CONWAY
HISTORIC DISTRICT COMMISSION
AUGUST

6:00pm • August 22, 2016 • City Hall

AGENDA

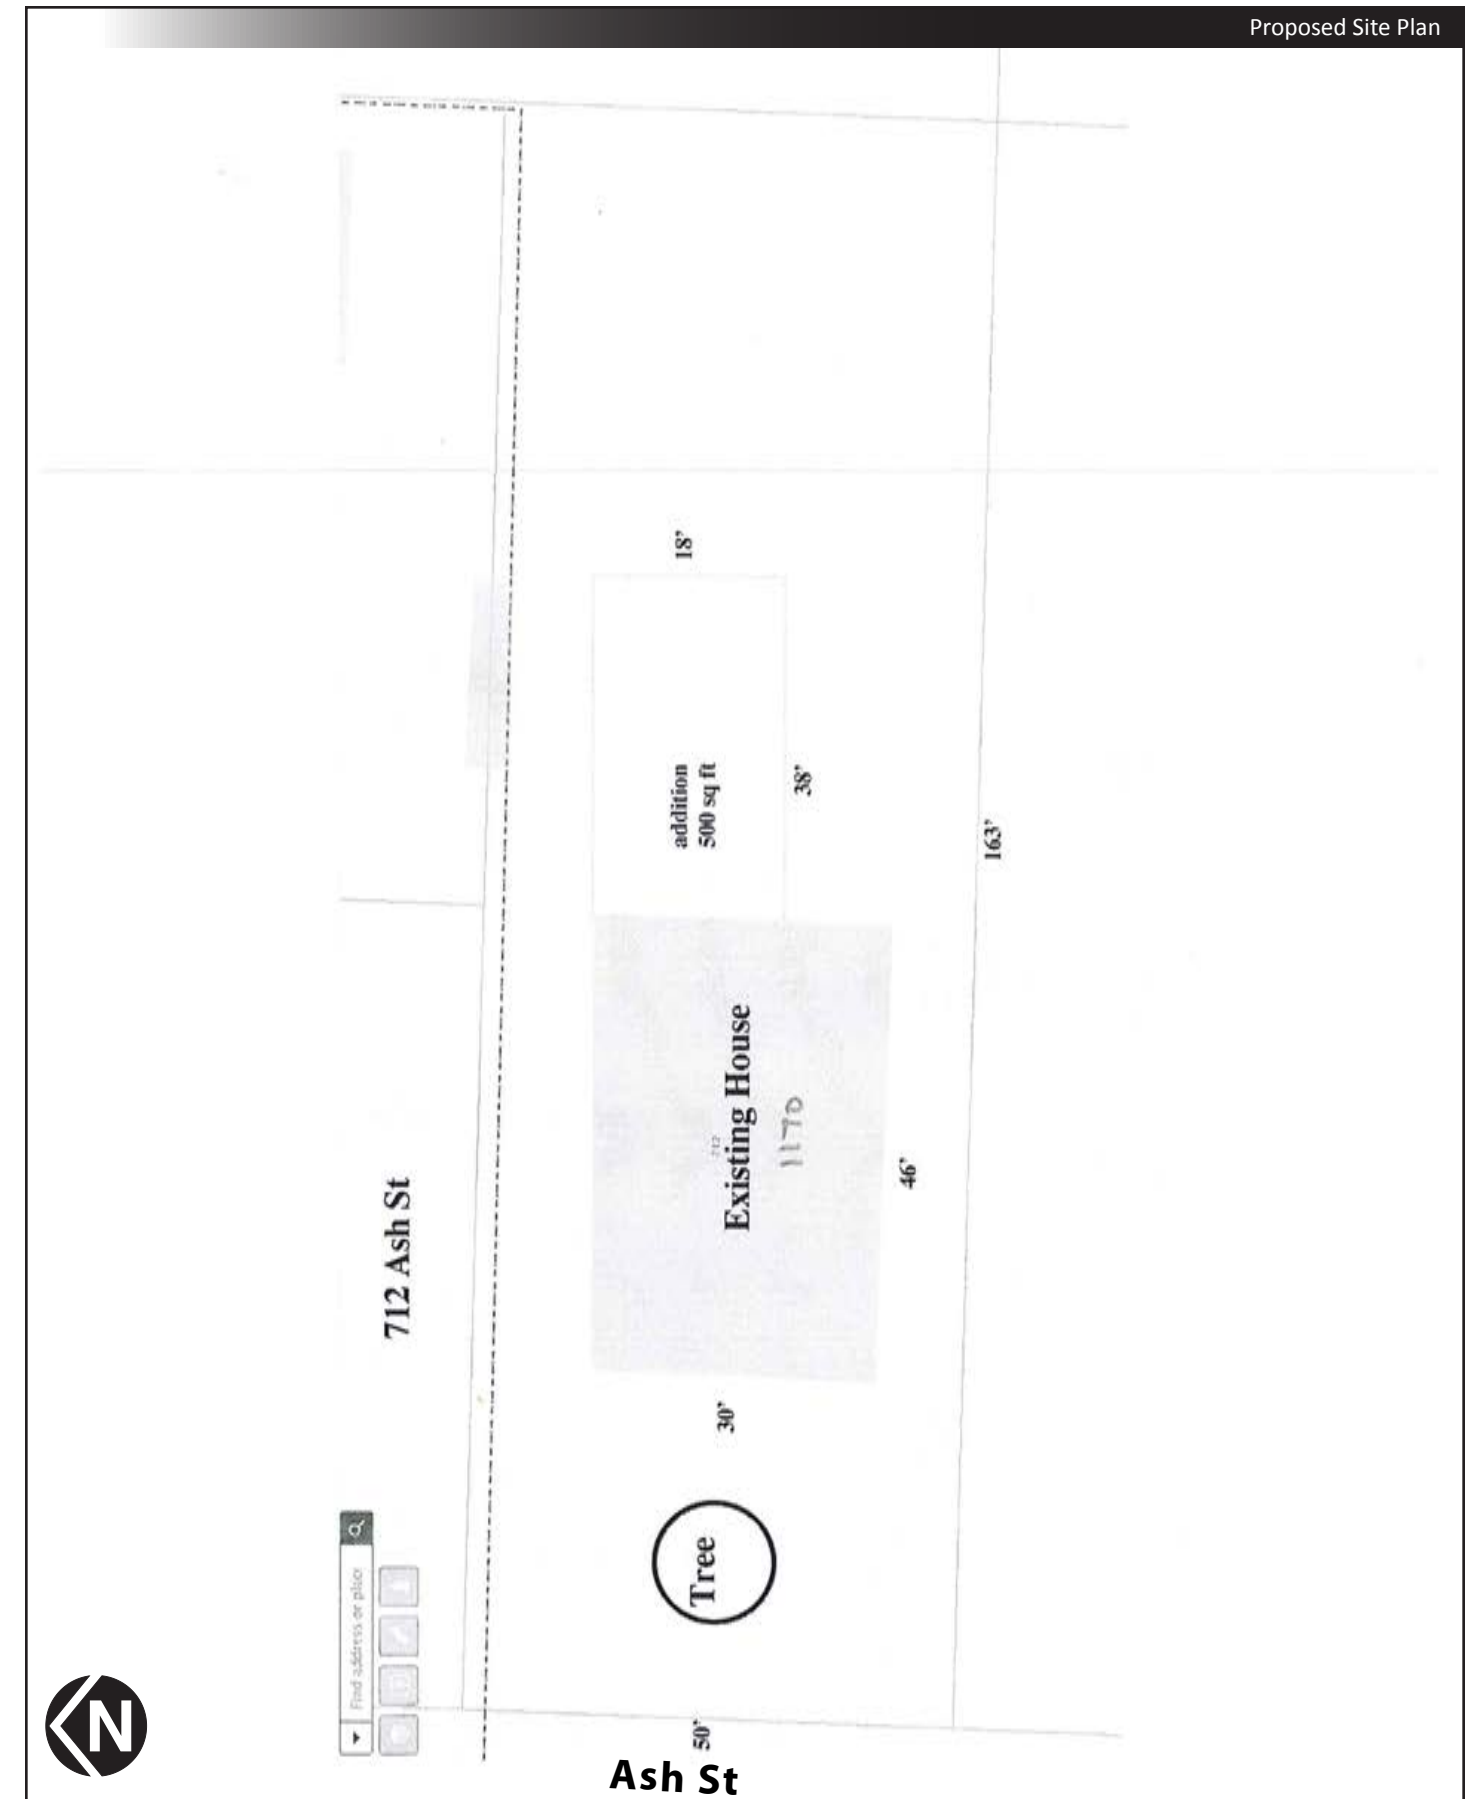
Façade, wall area, rhythm. Façades shall be compatible with surrounding historic structures in proportion of wall to opening area. The residence’s gables, porches, columns, and glass areas create façades compatible with other area traditional structures. The submitted drawings show window openings on the south and north façades. A door is possibly shown on the south façade. The applicant can supply additional information at the meeting.

Doors and windows. The rhythm, patterns, and ratio of voids to solids of new buildings should relate to and be compatible with adjacent façades; typically a higher proportion of voids to wall area. The existing residence has a large amount of windows on all façades. The submitted elevations show a measure of windows and possibly a door. The applicant can address the proposed number of windows and doors on the addition at the meeting. It appears that the residence has original windows. These windows should be restored.

1. The addition, open carport, and driveway shall be constructed as shown in submitted plans.
2. The addition will be clad with brick closely matching the existing residence.
3. A 10 foot concrete driveway may be constructed on the north side of the residence.
4. An open carport with a “0” foot setback shall be allowed on the north side of the residence.
5. Addition windows and doors?
6. The repair and restoration of the existing original windows is strongly encouraged.
